# CITY OF ARLINGTON NOTICE OF DECISION

## Smartcap Arlington Airport Preliminary Binding Site Plan Zoning Permit Decision

**Project Number:** PLN#942

**BINDING SITE PLAN  
STAFF REPORT AND PERMIT DECISION**

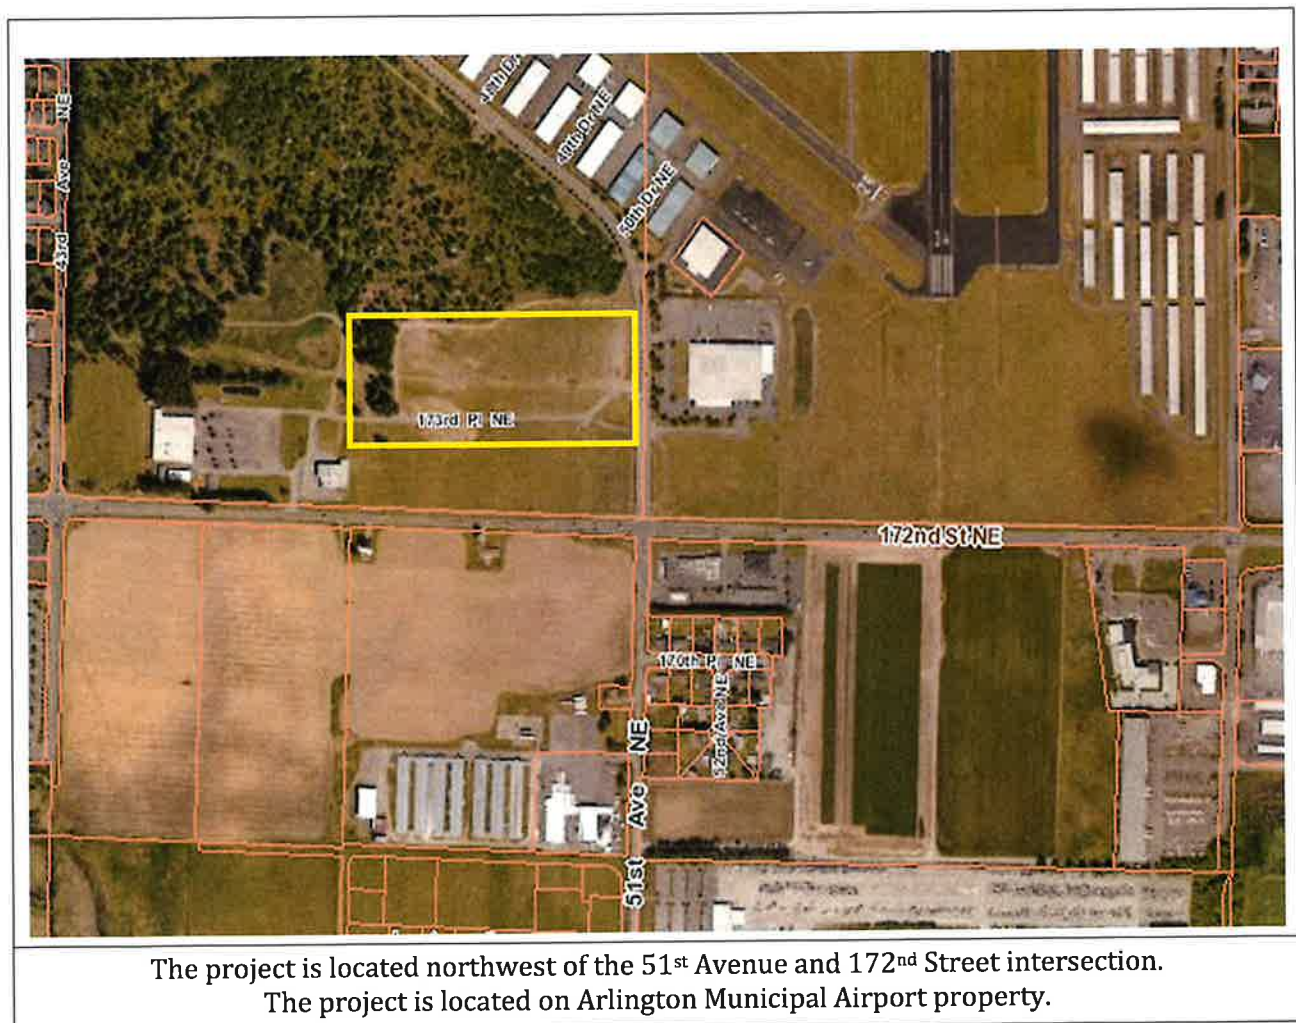
The applicant is proposing a binding site plan to divide the subject lease parcel into two separate lots. The total site consists of 16.87 acres and is located on the northwest corner of the 51st Avenue and 172nd Street intersection. The site is located on the Arlington Municipal Airport property and in the Business Park zone. The build out of the site proposes to construct two buildings on the site, one of which is already constructed. Lot A is proposed to construct a 136,705 square foot building and Lot B is proposed to construct a 168,494 square foot building.
